General Building Permit Application

Stepping Stone Lane
Project Name/Description

C-B-L: 406-F-52
permit # - 06-1425

Revised/Approved
 site plan for Lot # 2
 Stepping Stone Ln.

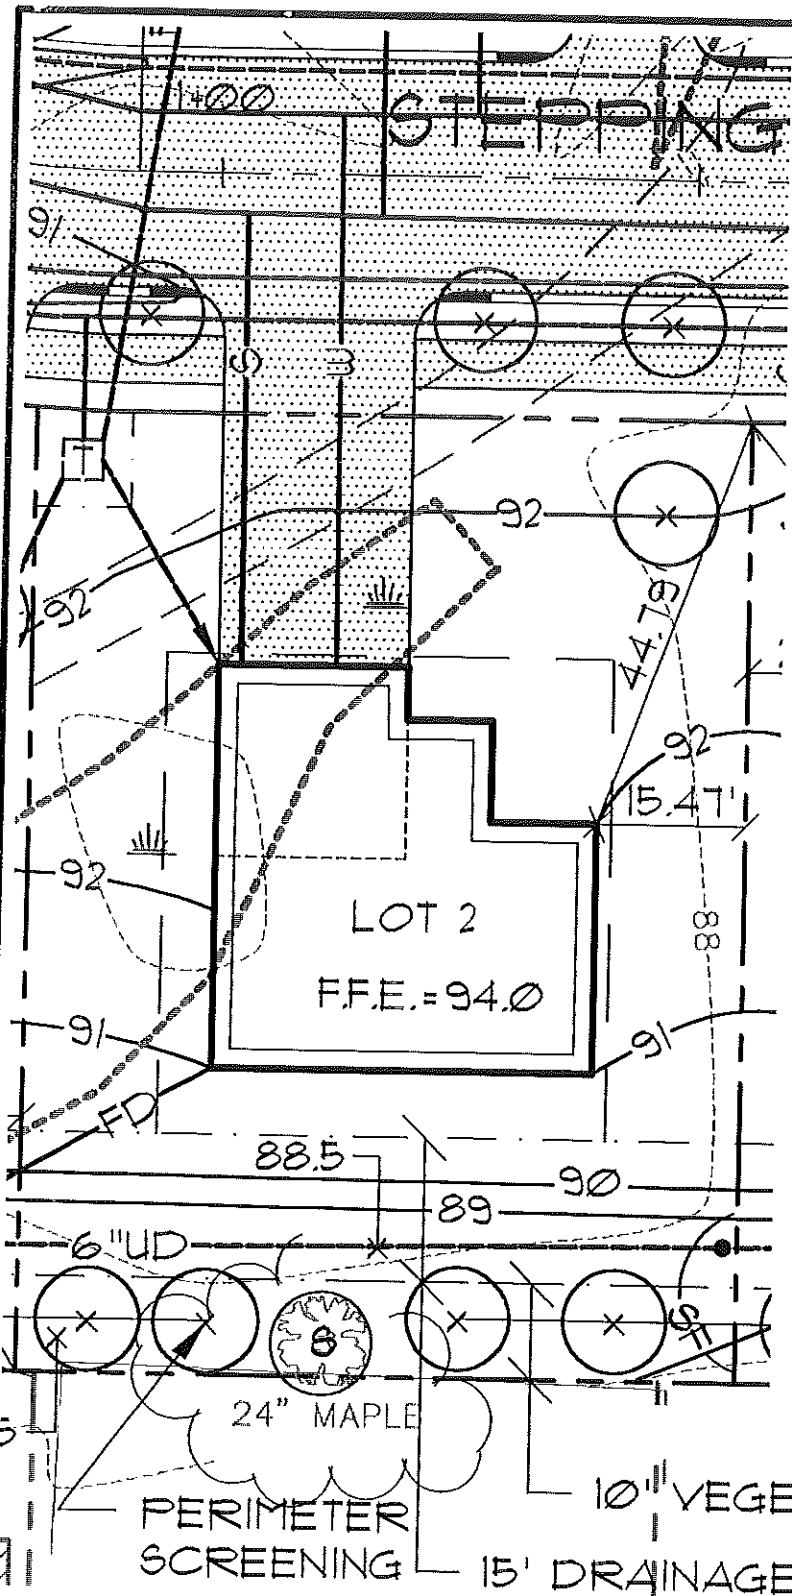
- no daylight basement

* need ²⁸ 32 total if ~~32~~
have 34.5 total so OK
* Chimney can extend into yard 2'
14-425

OK
26 x 40 = 1040
16.5 x 20 = 330
9 x 4.5 = 40.5
9.5 x 5.5 = 52.25
1462.75

LOT 2 - GRADING PLAN
AUTUMN GLEN SUBDIVISION

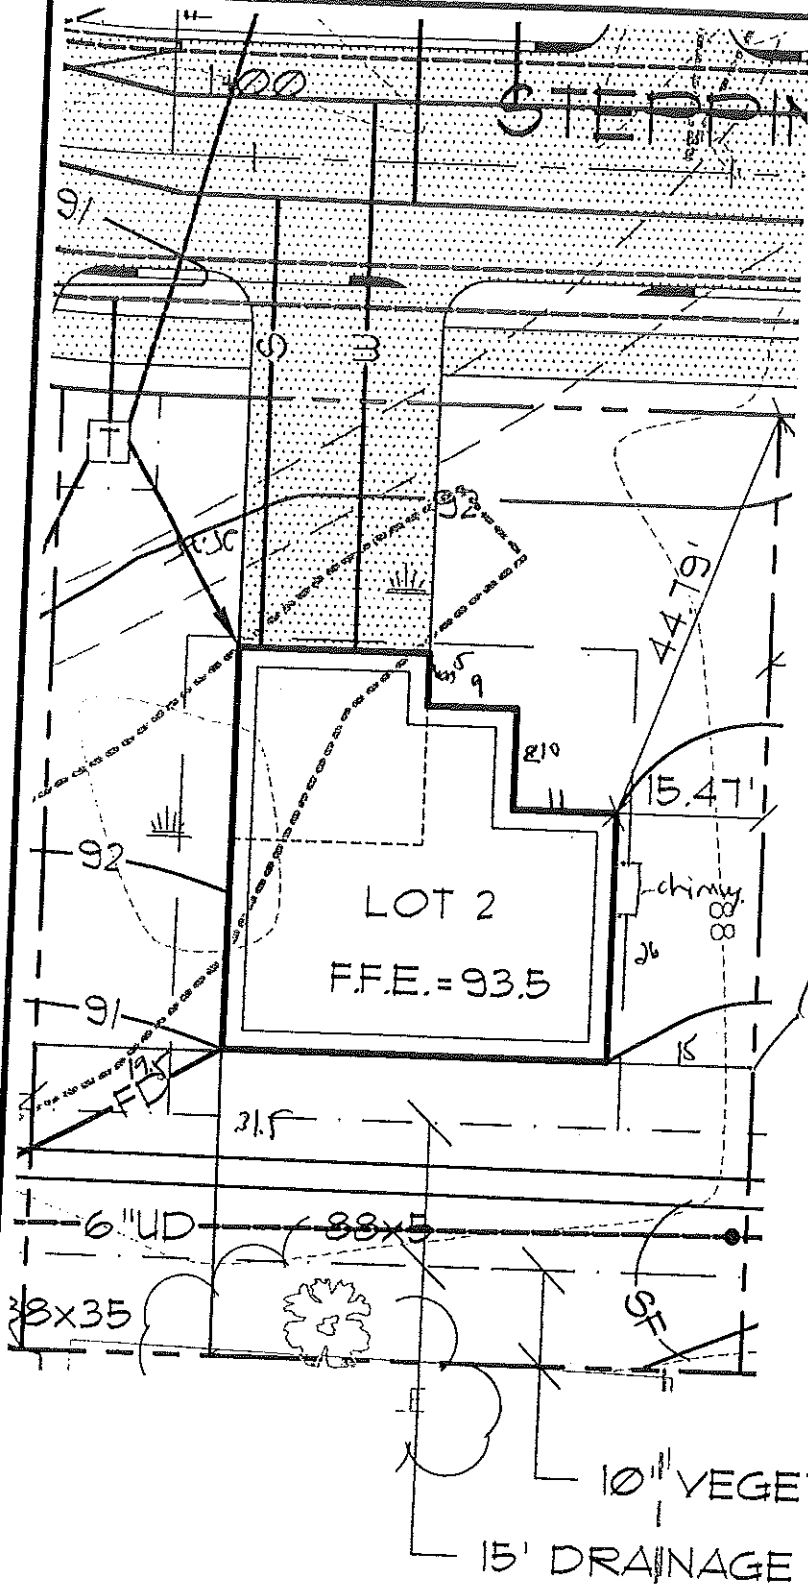
lot width 75'
